The Commission has issued the enclosed Amendments Nos. 95 and 97 to Facility Operating Licenses Nos. DPR-44 and DPR-56 for the Peach Bottom Atomic Power Station, Units Nos. 2 and 3. These amendments consist of changes to the Technical Specifications (TSs) in response to your request dated April 4, 1983.

These amendments provide clarification of an isolation trip feature on the High Pressure Coolant Injection (HPCI) system. The change provides a statement in the Notes For Table 3.7.1 indicating that one of the HPCI steam line exhaust drain valves does not actuate upon receipt of one of the Group 4 isolation signals. Isolation of the HPCI steam exhaust drain line is, however, provided by existing isolation provisions that meet the provisions of Standard Review Plan 6.2.4 and TMI Action Plan II.E.4.2.

SAFETY EVALUATION BY THE OFFICE OF NUCLEAR REACTOR REGULATION
SUPPORTING AMENDMENTS NOS. 95 AND 97 TO FACILITY OPERATING LICENSES

PEACH BOTTOM ATOMIC POWER STATION, UNITS NOS. 2 AND 3

Figure 1. Valve Arrangement For HPCI Turbine Exhaust System

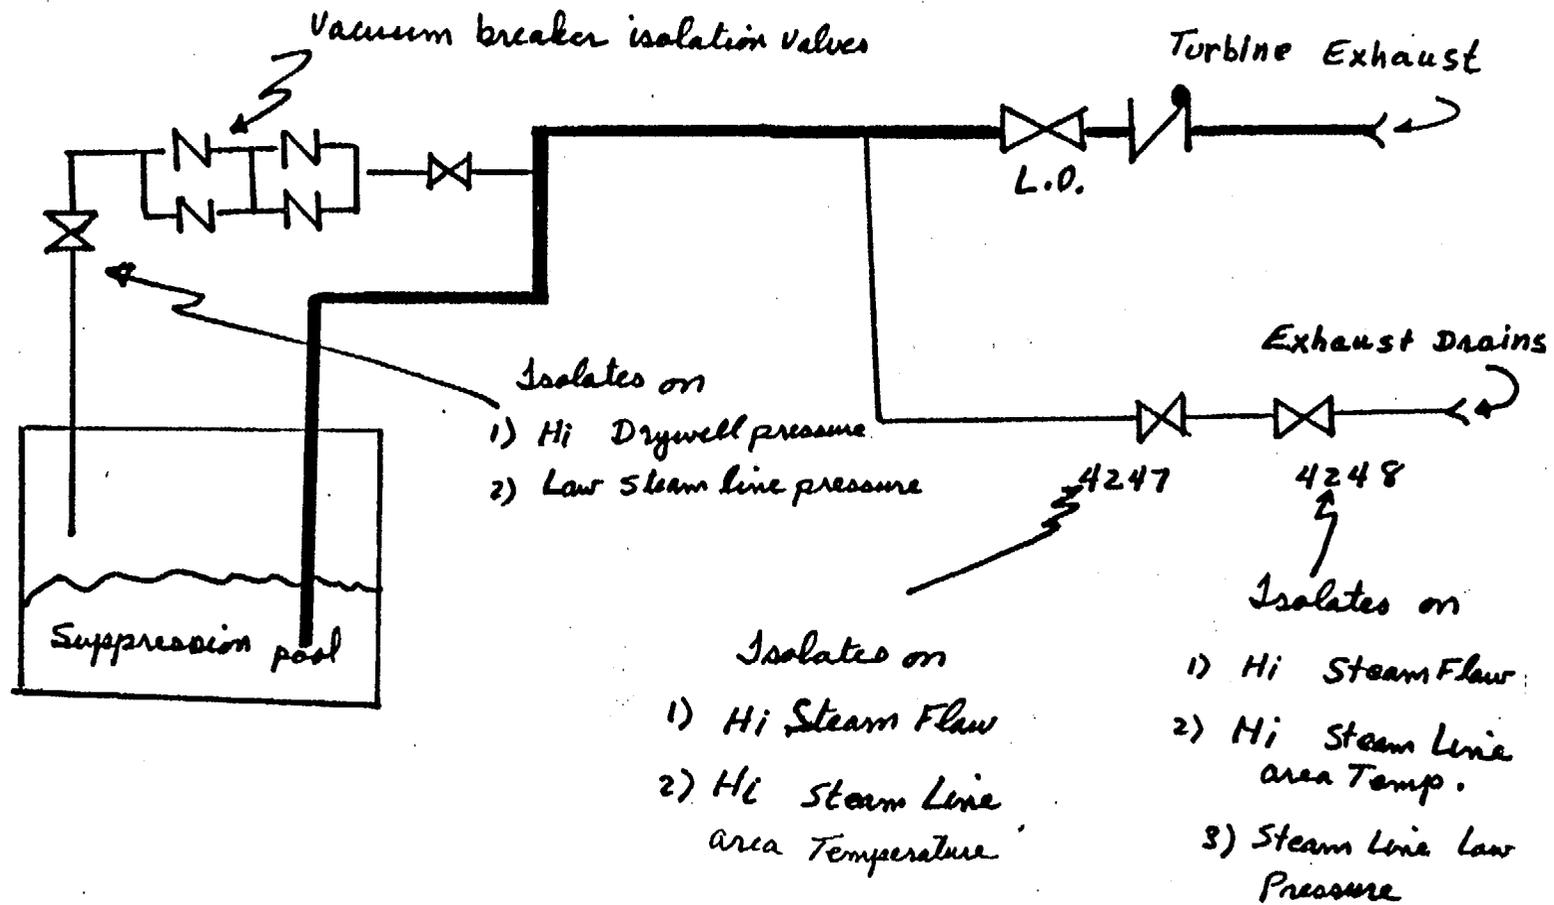
The two inch High Pressure Coolant Injection (HPCI) turbine exhaust drain line is provided with redundant isolation valves (4247 and 4248 for Peach Bottom, Unit 2, and 5247 and 5248 for Peach Bottom, Unit 3). The licensee stated that the current Technical Specifications (Table 3.7.1, page 181) regarding the isolation signals to isolate the HPCI turbine exhaust drain line include: 1) high HPCI steam flow; 2) high temperature along the HPCI steam line or in the HPCI equipment room; and 3) HPCI low steam line pressure.

The licensee states that a review of the as-built configuration shows that valve 4248 (5248) receives all of the three isolation signals listed above; however, valve 4247 (5247) receives only signals 1 and 2, above. The licensee has requested that Table 3.7.1 be modified to reflect the actual isolation signals provided to each valve (See attached Figure 1).

The licensee states in their April 4, 1983 submittal that the absence of the low steam line pressure signal from the set of isolation signals for one of the two valves does not compromise the diversity requirement. The diversity requirement is satisfied by the steam line high flow and HPCI steam line space high temperature, which would be generated as a result of HPCI steam line break. The licensee further states that shutdown of the system after it has performed its safety-related function is not affected by the absence of the low steam line pressure signal from the set of isolation signals for one of the two valves. This is due to the redundant isolation valve on the line connecting the turbine exhaust line with the gas side of the suppression chamber, which does receive a HPCI steam line low pressure signal. On the parallel line, the suppression pool water provides a redundant isolation barrier. In this regard, we agree with the licensee's analysis that the HPCI steam line low pressure signal is a process signal and need not be provided

for valve 4247 (5247). The basis for this conclusion is that reasonable isolation provisions that meet the provisions of Standard Review Plan 6.2.4 and TMI Action Plan II.E.4.2 are provided by the existing isolation signals and by the redundant barriers as explained above.

We conclude, based on the above considerations, that the proposed change to the Technical Specifications is acceptable.
